拉合尔供水与污水处理项目（LWWMP）
AIIB 项目编号 P000074 合同编号 0074-PAK-01

第三版澄清文件

拉合尔污水处理与排水管理项目（LWDMP）——从LARECHS COLONY至GULSHAN E

投标人疑问的第三版澄清文件

ODOR CONTROL SYSTEM (SINGLE LINE DIAGRAM) TYPICAL

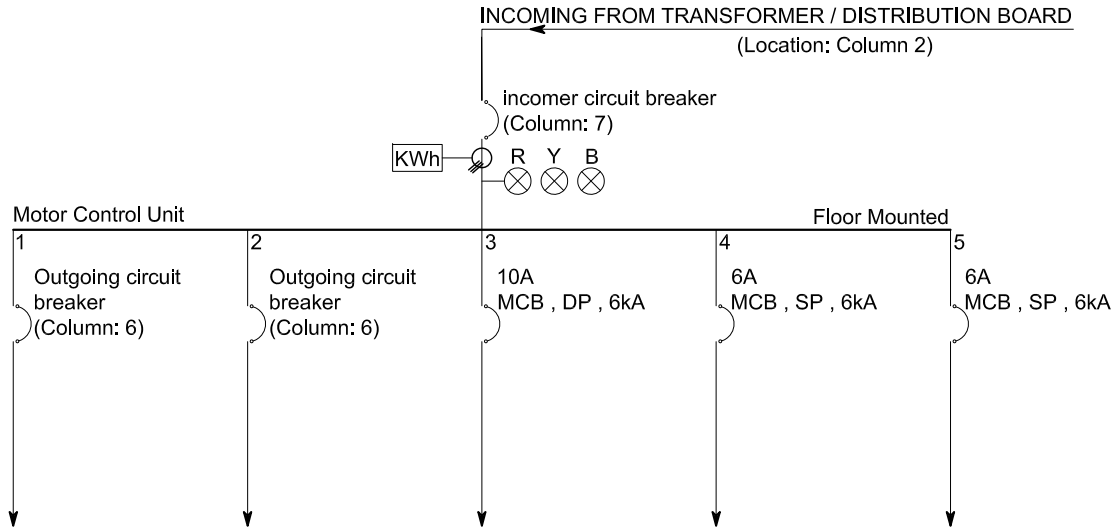
Sr #	Reference Section	Description	Employer's Response
1.	Volume 1, Part I, Section 4, Tender Forms Page 4-46-4-62 Schedule No. 5: Electrical Works	Electrical works in 23 Intermittent Pumping Stations Electrical works along sewer lines (15 Nos. Control System at Drop Structures) & 15 Nos. Control Points on Manholes along Lines and Laterals preferably at drop structures in accordance with ER Sub Clause 4.1 & 5.15 Nos. (minimum) Control Points on Manholes along Lines and Laterals ULTIMATE DISPOSAL STATION AT GULSHAN E RAVI (ELECTRICAL WORKS FOR PUMPING STATION AND ALL BUILDINGS REFERRED IN EMPLOYER'S REQUIREMENTS The Tenderer notes that only the Single Line Diagram (SLD) for the Disposal Station has been provided. The Tenderer respectfully requests the Employer to provide the load list, SLDs, layout drawings, and any additional electrical drawings for other stations, if available.	It is to clarify that EPC Contractor is responsible for detailed design of loads and SLDs for all the stations, however, the load requirement for all 23 intermittent pumping stations and typical SLDs for odor control system, ventilation system and screening system is attached as Annex-A for guidance only.

ULTIMATE DISPOSAL STATION
MASTER LAYOUT PLAN PUMP HOUSE

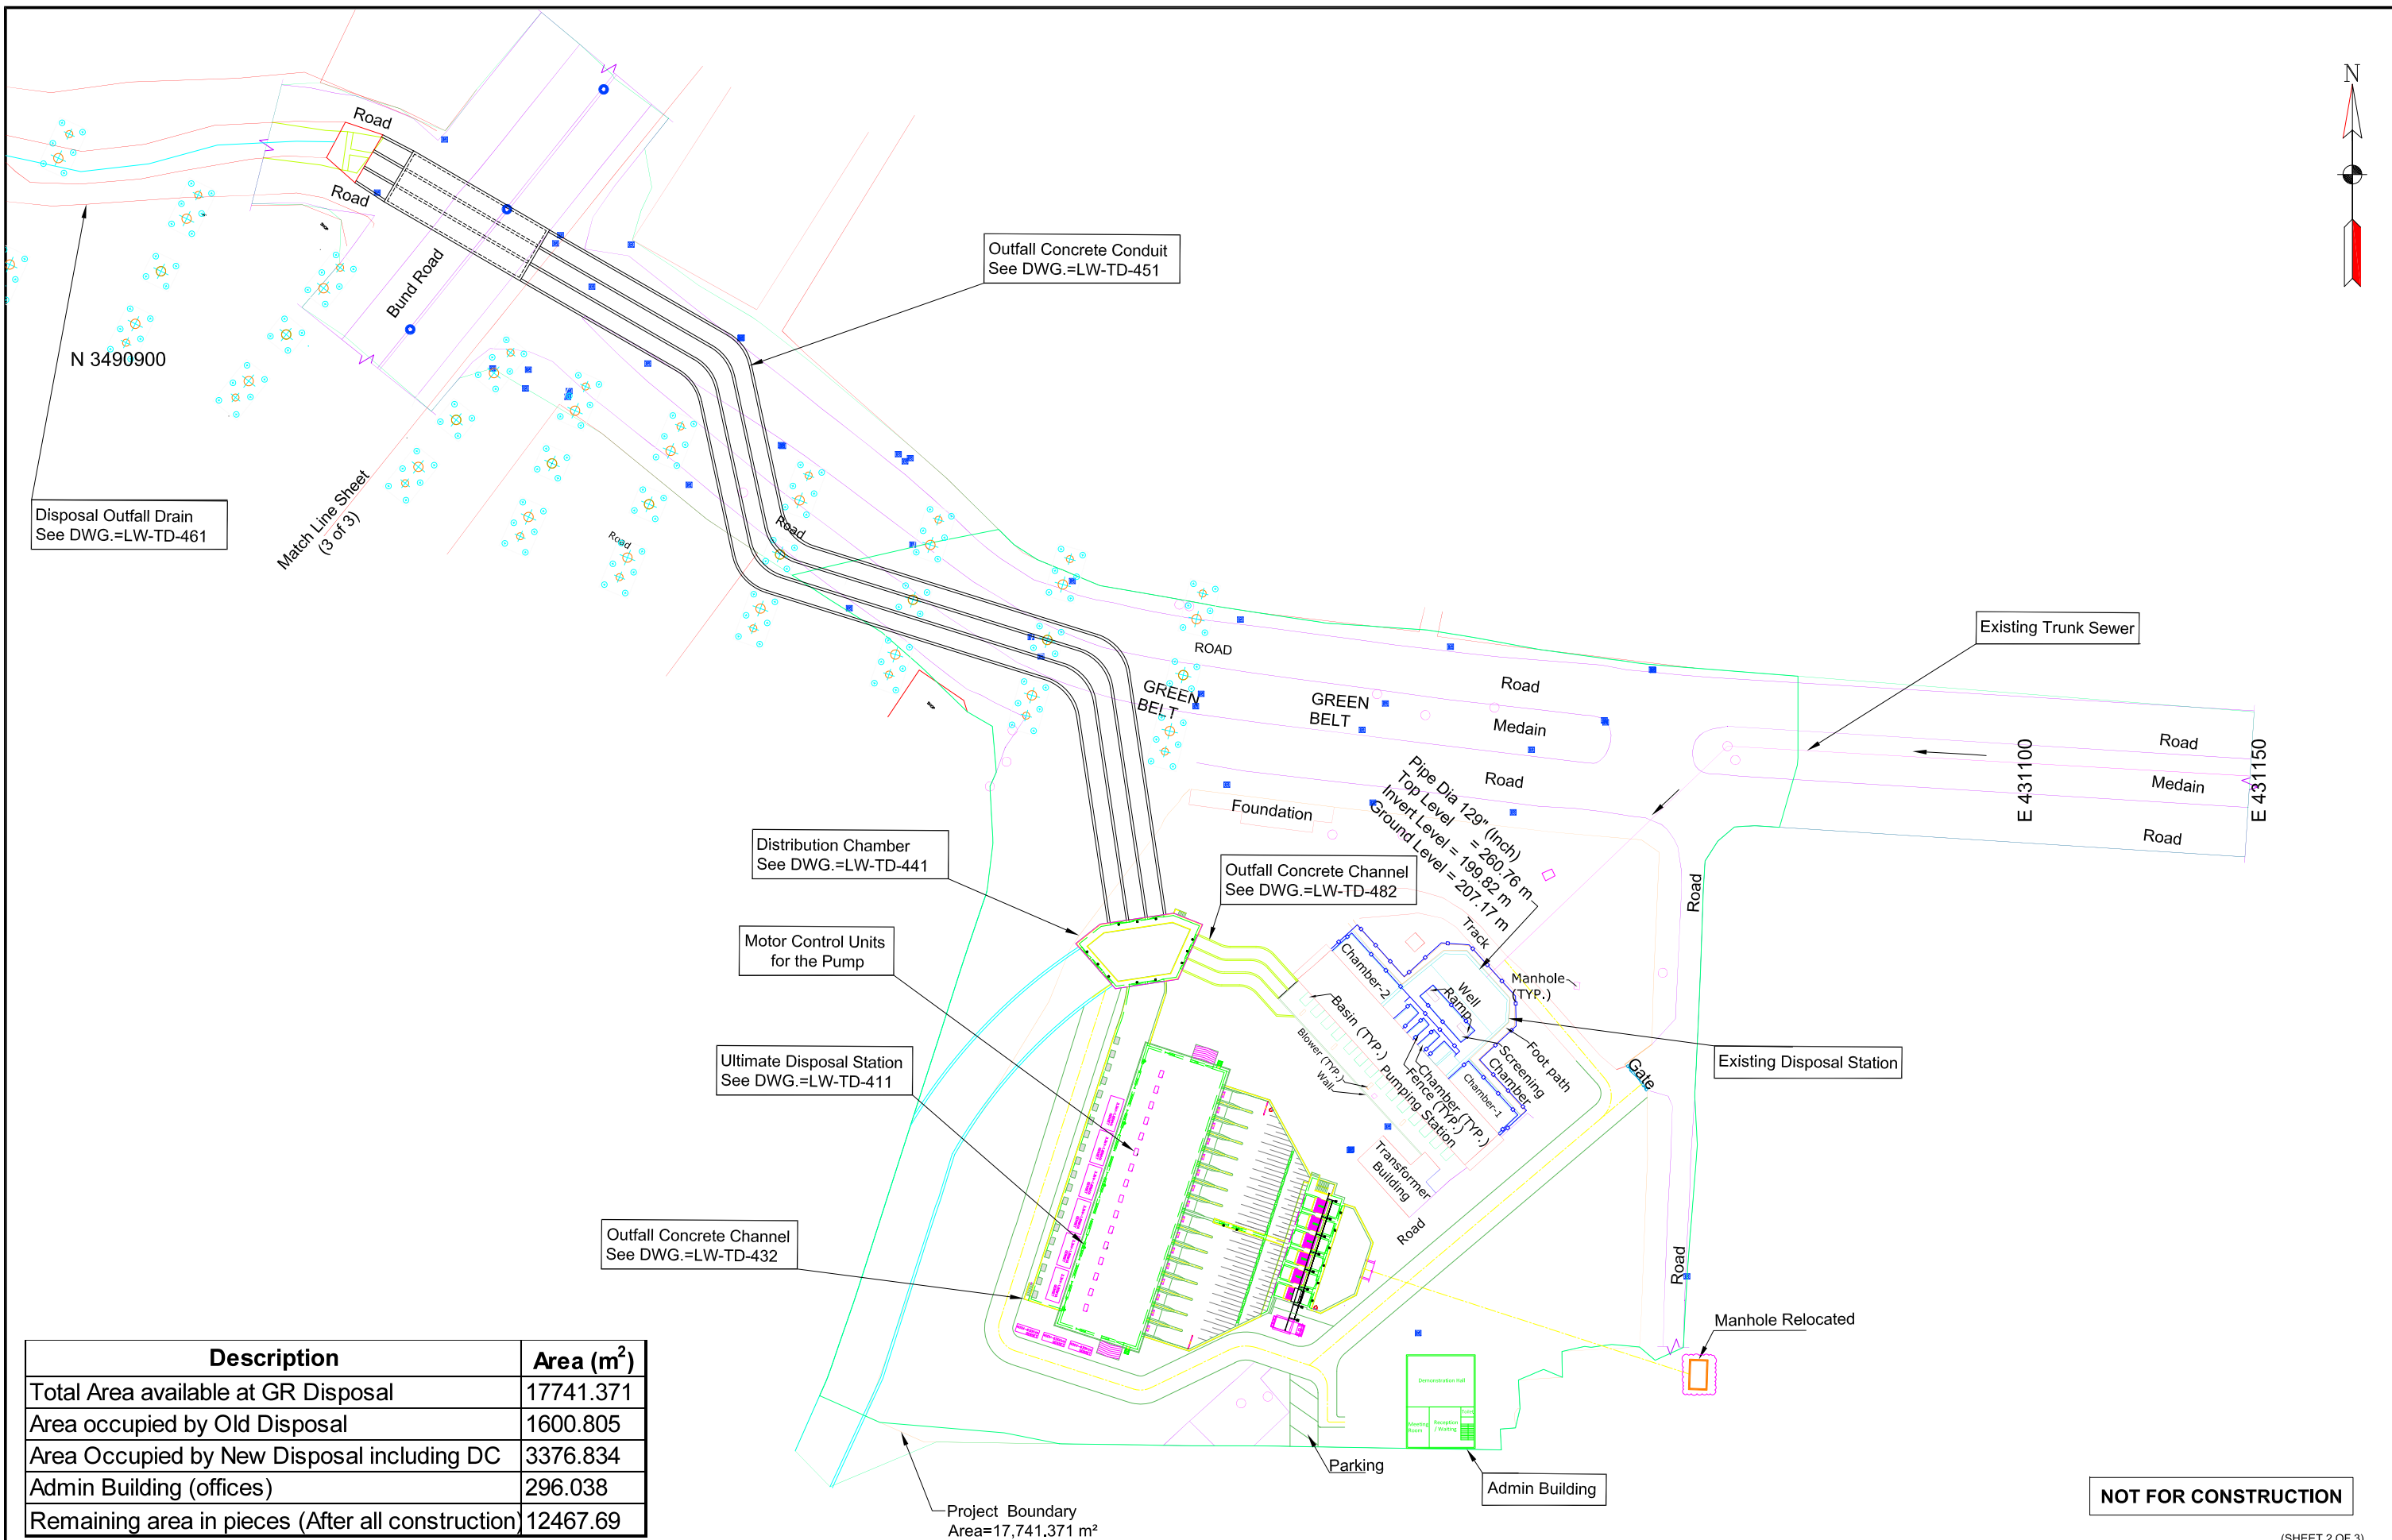
2.	Volume 2 Part II, Section 6, Employer's Requirements	It is recommended that the panel rooms can be adjusted in the dry well chamber. Can this alternate arrangement be acceptable to the Employer.	Kindly refer to response at Sr. No. 39 of the Clarifications and Minutes of Meeting of 1st Pre-Tender Meeting, wherein, the updated drawing # LW-TD-411 shall prevail, however, as an alternative arrangement, the panel rooms can be adjusted in the dry well chamber as per Annex-B.
